Descriptive Report to Accompany Hydrographic Survey H11231

Project OPR-P182-RA-03
Southwest Alaska Peninsula, Alaska
Scale 1:10,000
July - August 2003
NOAA Ship RAINIER
Chief of Party: Commander John W. Humphrey, NOAA

Revisions Compiled During Office processing and Certification

Figure 2. H11231 Junction Surveys.

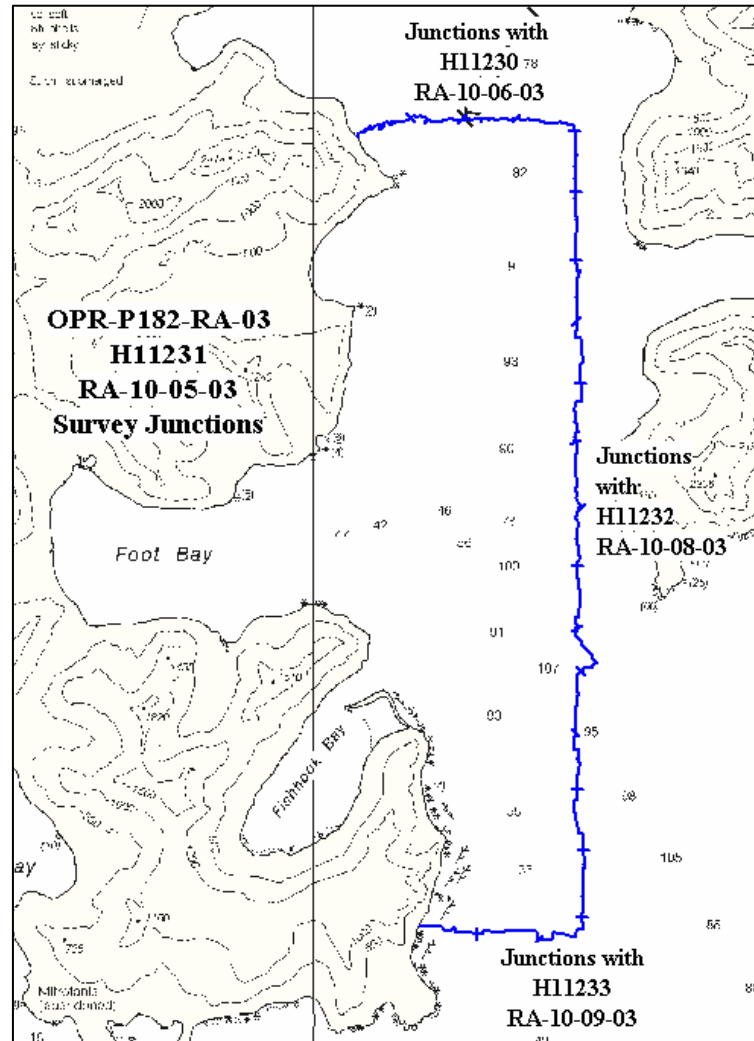
The following contemporary survey junctions with H11230 and H11232⁷:

<u>Registry #</u>	<u>Scale</u>	<u>Date</u>	<u>Junction side⁸</u>
H11230	1:10,000	2003	North
H11232	1:10,000	2003	East
H11233	1:10,000	2003	South

Surveys H11232 and H11233 junction well with this survey, a cursory comparison indicates differences are generally one to two fathoms in deep water and within 1 fathom difference near shore.⁹

Survey H11230 was not complete at the time of this report. The soundings at this junction have not been compared.¹⁰

⁷ Strikethrough ~~H11230 and H11232~~, replace with “H11231”.

⁸ In PHB processing, H11231 was also compared at its southwestern junction with LIDAR survey H11261 (OPR-P182-KRL-04). The comparison showed good correlation, generally to within 1 to 2 fathoms. MHWL revisions, sounding and features from LIDAR data have been applied to the Hdrawing in near-shore areas where H11231 multibeam or VBES data did not extend. Data from LIDAR source is found on Level 7 of the Hdrawing. All junction surveys have been considered in compiling the Hdrawing.

⁹ Concur.

¹⁰ Office comparison of survey H11231 with completed survey H11230 showed good correlation, generally to within 1 to 2 fathoms.

Figure 3. Photograph of Shoreline and Feature on Land at MLLW.

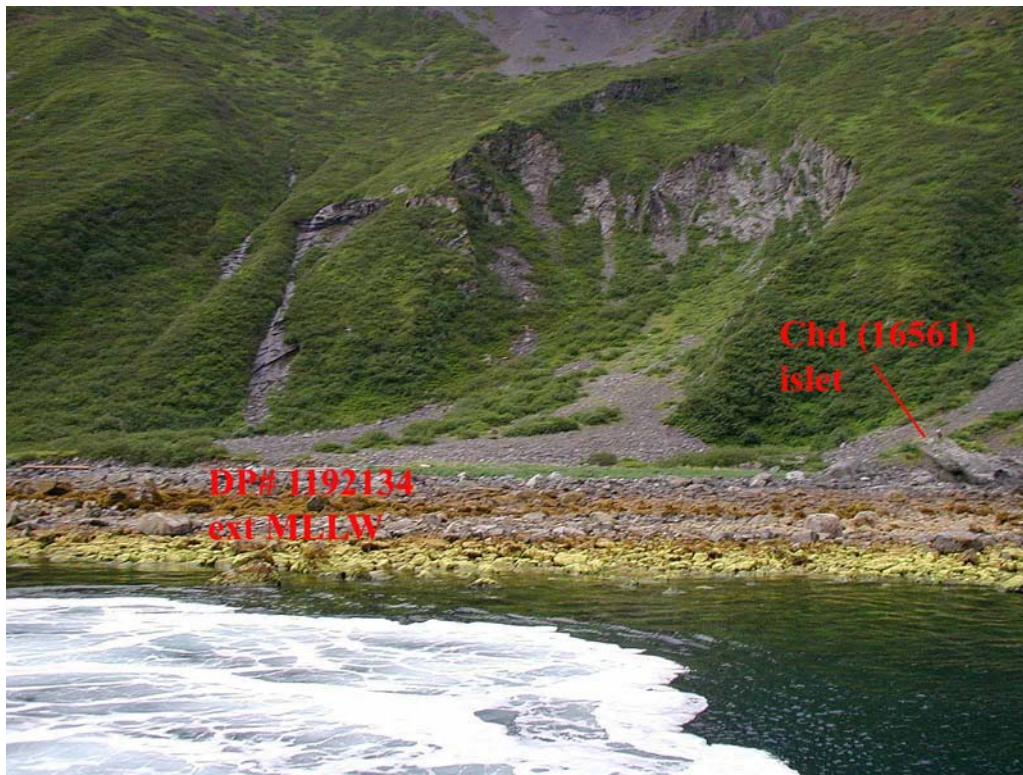
The charted (16561) islet (*Figure 3*) at 56°00'24.674"N, 158°39'52.852"W (520909.37E, 6206893.14N) is a high point on land and at the CFF MHW. The Hydrographer recommends removing the islet from the chart.³¹

³¹ Concur. Chart vicinity according to the smooth sheet.
